City of Aurora Building Division
Reviewed for Code Compliance
Approved as Noted: *John Lichtner*
Date: **Oct 18, 2017**
2015 INTERNATIONAL CODES & 2017 NEC

City of Aurora Building Division
Project: **DAVITA EXIT DOOR RELOCATION**
Address: **1411 S POTOMAC ST UNIT 100**
Occupancy Group: **IBC-B**
Construction Type: **UBC-II-1 HR -SPK**
RSN: **1245509**
Permit: **17-1372798-TF**

RELOCATION OF SINGLE EXIT DOOR FOR

DAVITA

LIFE SAFETY PLAN
A0.0

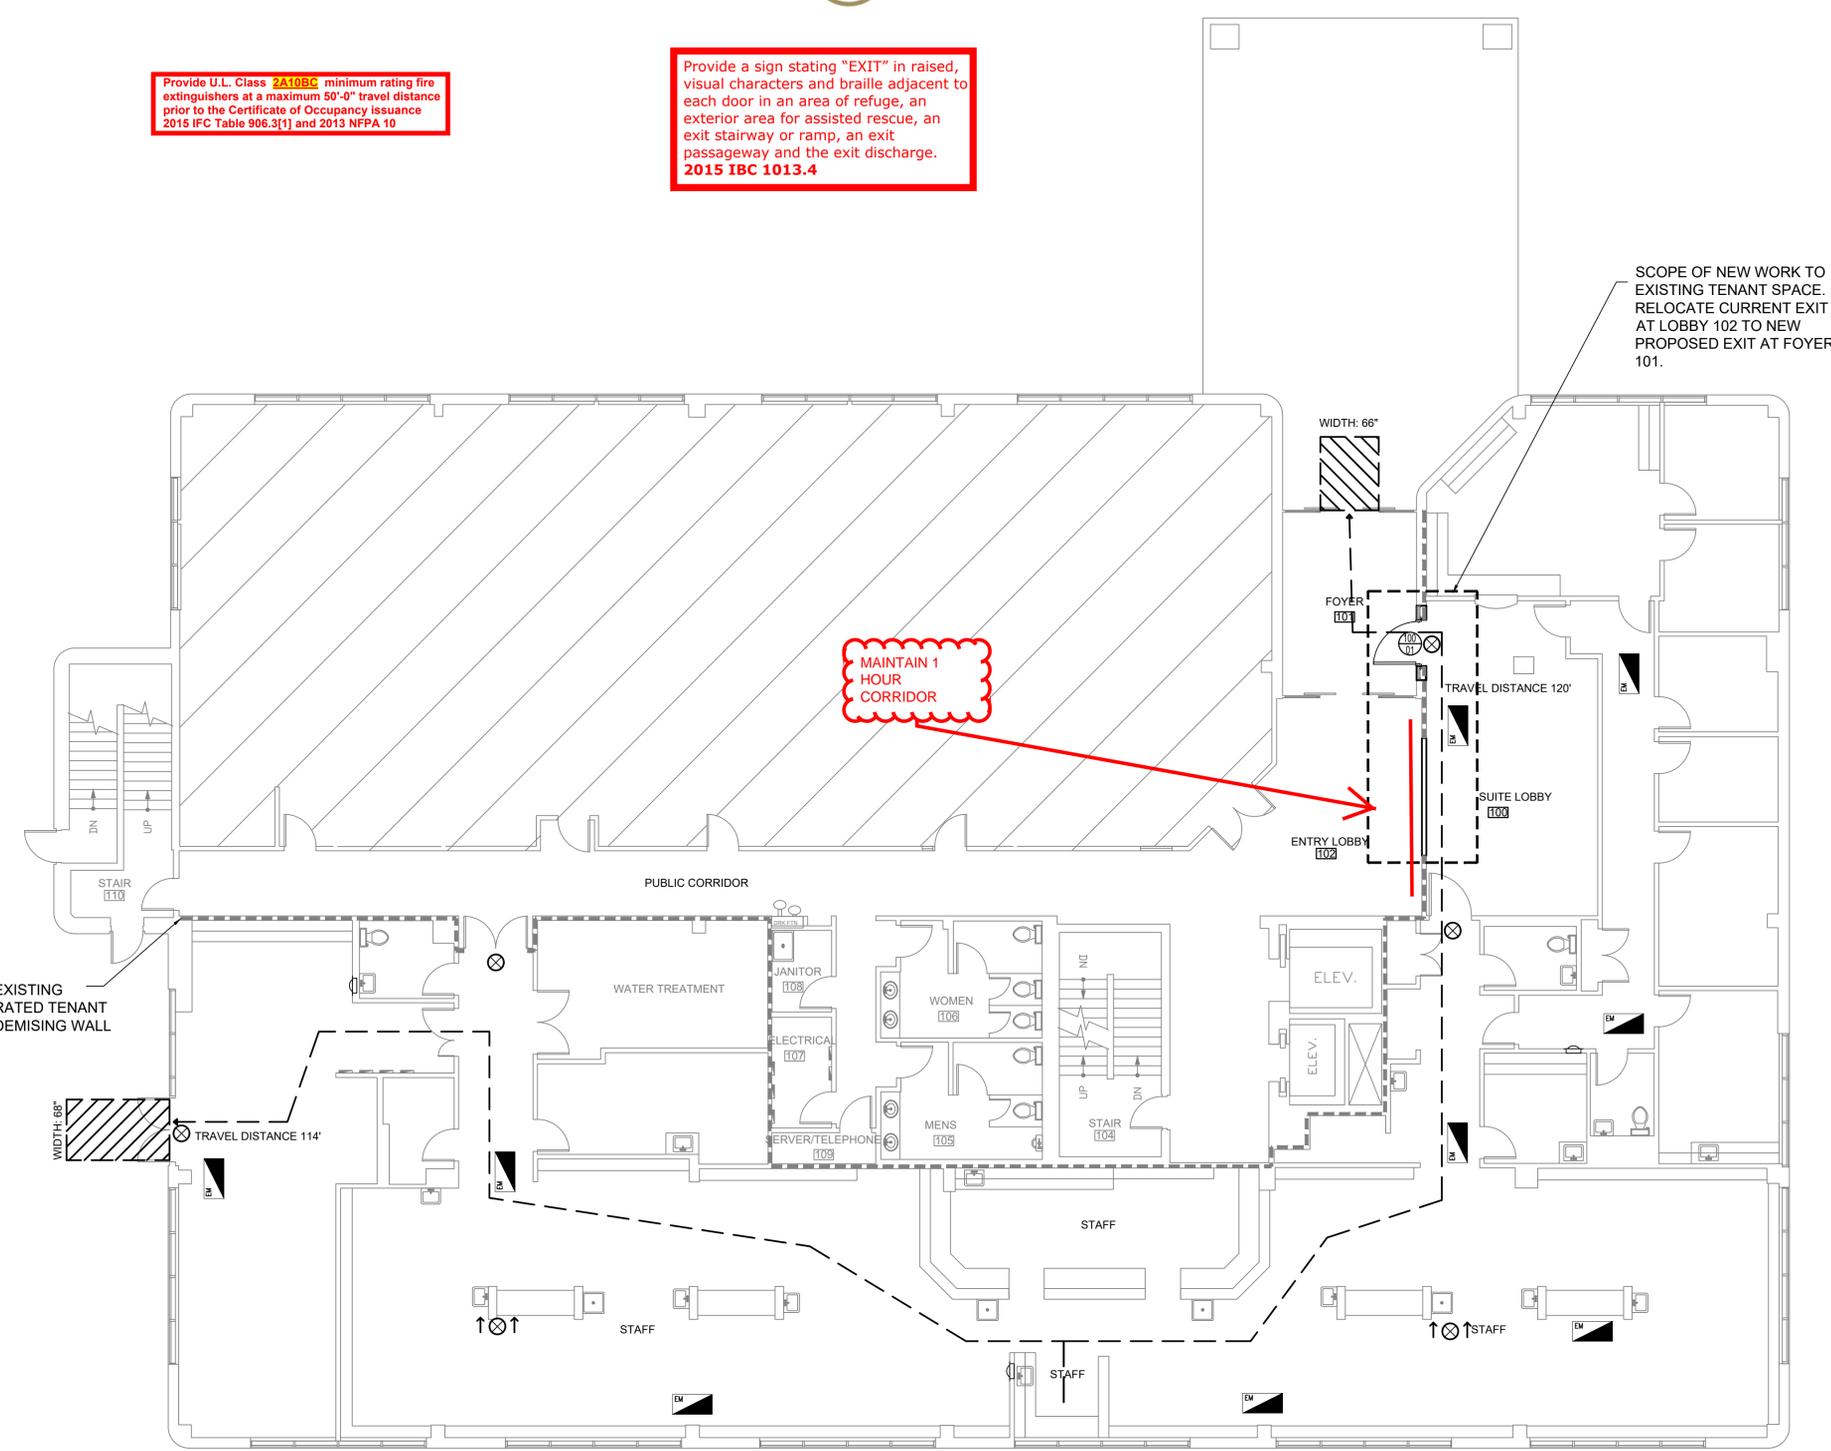
Consultation for fire extinguisher placement is available upon request. Call 303-739-7420 prior to final Life Safety inspection to verify proposed locations.

Provide U.L. Class 2A10BC minimum rating fire extinguishers at a maximum 50'-0" travel distance prior to the Certificate of Occupancy issuance 2015 IFC Table 906.3(1) and 2013 NFPA 10

Provide a sign stating "EXIT" in raised, visual characters and braille adjacent to each door in an area of refuge, an exterior area for assisted rescue, an exit stairway or ramp, an exit passageway and the exit discharge. 2015 IBC 1013.4
